ALLSTON INTERCHANGE

Proposed Riverbank Conditions – General Design Considerations

Option 1 - What We Heard

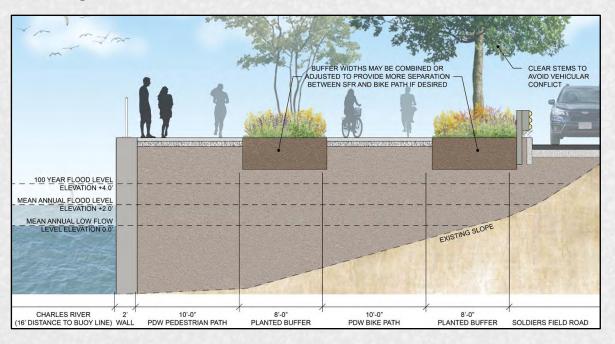
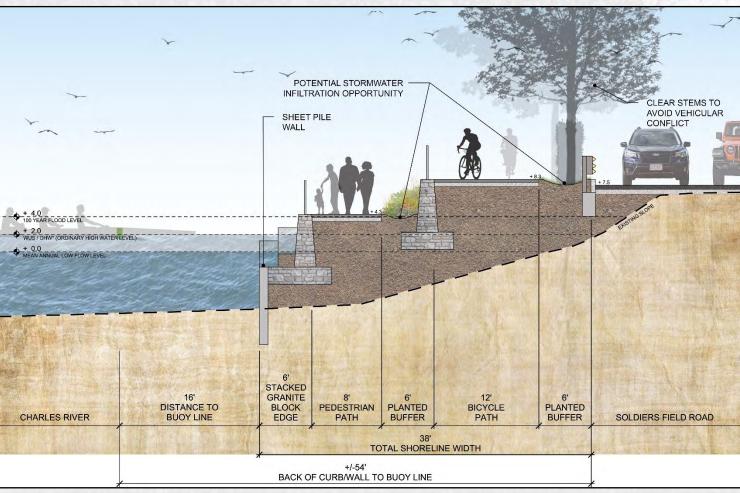
- Vertical Wall
 - creates significant wave deflection concerns (River Users)
 - provides no opportunities for river user respite or rescue (River Users)
 - provides little to no ecological value (River Users & Permitting Agencies)
- Significant river impact due to maximized fill (Permitting Agencies)
- Provides most easily maintained shoreline treatment (DCR)
- Allows for healthy and maintainable planting buffers at path edges (DCR)
- Road traffic will be loud and uninviting (River Users)

- Explore option to improve river's edge treatment to reduce wave deflection and provide areas of respite
- To maintain ease of maintenance access, unlikely to be able to provide a planted river's edge without increasing volume of river fill (which is already maximized).
- Consider opportunities to reduce traffic noise

Option 2 - What We Heard

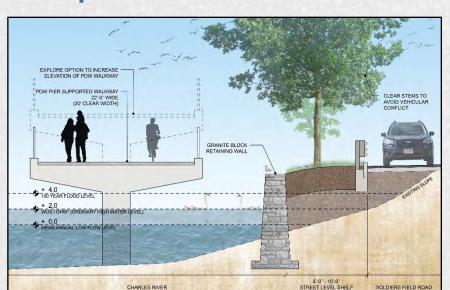
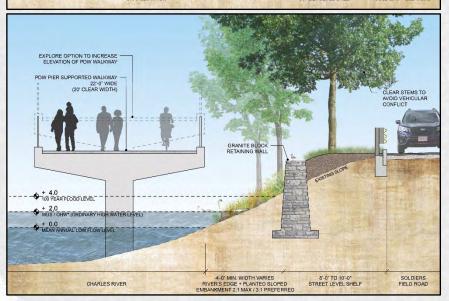
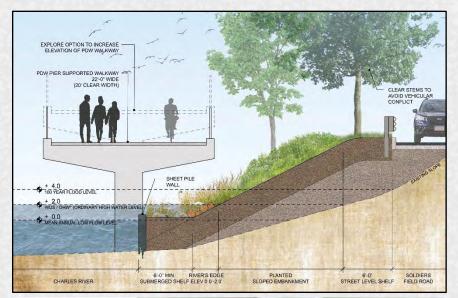
- Raised Walkway in river reduces usable water sheet and presents a safety issue for river users (i.e. navigation obstacle and head height concern) (River Users)
- Raised Walkway inhibits access to shoreline from watersheet (River Users & DCR)
- While the planted shoreline is desirable, it is limited in length and narrow (River Users)
- Challenging planting environment on north facing slope (River Users & DCR)
- Significant river impact due to fill (Permitting Agencies)
- Shoreline is inaccessible for maintenance purposes (DCR)
- Planted terraces and range of conditions are difficult to maintain (DCR)
- Pile Supported Walkway is difficult to maintain and plow (DCR)
- Safety concerns if disconnected from land (River Users)
- Potentially improve parkway experience (MassDOT & DCR)

- Explore option to increase height of walkway to reduce head height concerns
- Reduce number of pile supports to lessen conflicts on water sheet (i.e. explore a mono pier type structure)
- Even if raised, conflicts at landing points remain
- Unlikely to be able to improve DCR's maintenance access concerns

Option 3 - What We Heard

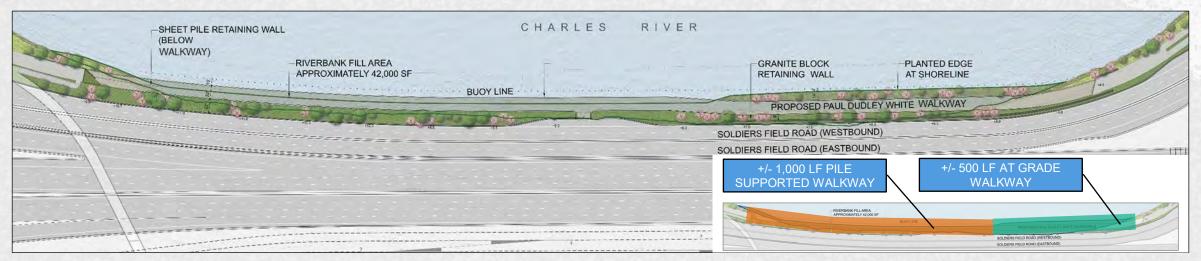
- Consider opportunities to expand locations of shoreline to improve river user's ability to pull up along land (MassDOT & River Users)
- Provides some ecological value but not extensive (River Users)
- Number of different planting conditions for at-grade portion could be reduced to improve ease of maintenance (DCR)
- · Raised Walkway presents same challenges as other options (River Users & DCR)
- Significant river impact due to maximized fill (Permitting) Agencies)
- Potentially provides some desirable stormwater infiltration opportunities (DCR & Permitting Agencies)
 Road traffic might be loud and uninviting at some locations
- (River Users)

- Explore options to better distribute locations of planted shoreline to improve river user's experience
- Cannot increase planted shoreline length without increasing river fill.
- · Potential to reduce number of different planting conditions to improve ease of maintenance
- Explore opportunities to reduce wave deflection
- Consider opportunities to reduce traffic noise

Option 4 - What We Heard

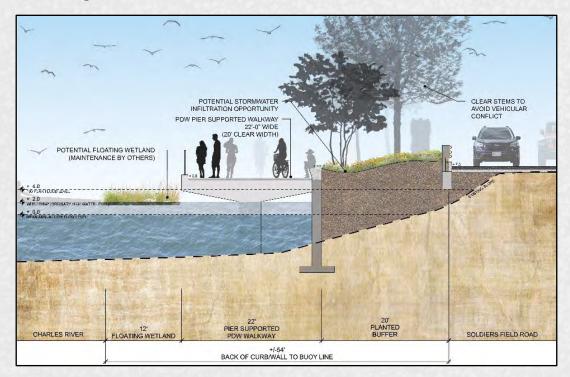
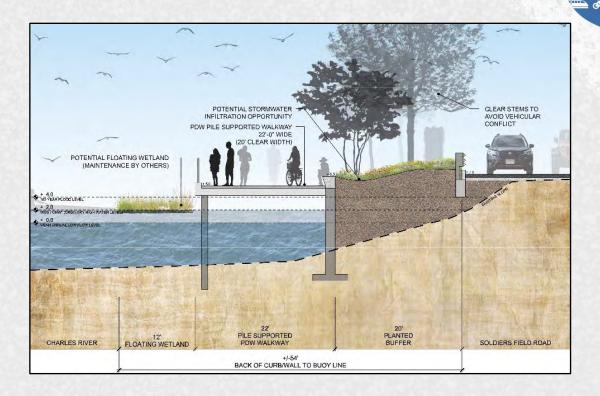
- Vertical Wall
 - creates significant wave deflection concerns (River Users)
 - provides no opportunities for river user respite or rescue (River Users)
 - provides little to no ecological value (River Users & Permitting Agencies)
- Raised Walkway in river reduces usable water sheet and presents a safety issue for river users (i.e. navigation obstacle and head height concern) (River Users)
- Reduced river fill is desirable (Permitting Agencies)
- Provides a more easily maintained planting area and walkway (DCR)
- Potentially provides some desirable stormwater infiltration opportunities (DCR & Permitting Agencies)
- Provides minimal ecological benefit at river's edge (River Users and Permitting Agencies)
- Road traffic will be loud and uninviting (River Users)

- Explore option to improve river's edge treatment to reduce wave deflection and provide areas of respite
- Reduce number of pile supports to lessen conflicts on water sheet (i.e. explore a mono pier type structure)
- This option includes a walkway structure fixed to land (as opposed to Option 2) to promote utility/drainage design efficiency. Raising walkway could be explored however
- · Even if raised, conflicts at landing points remain
- Consider opportunities to reduce traffic noise
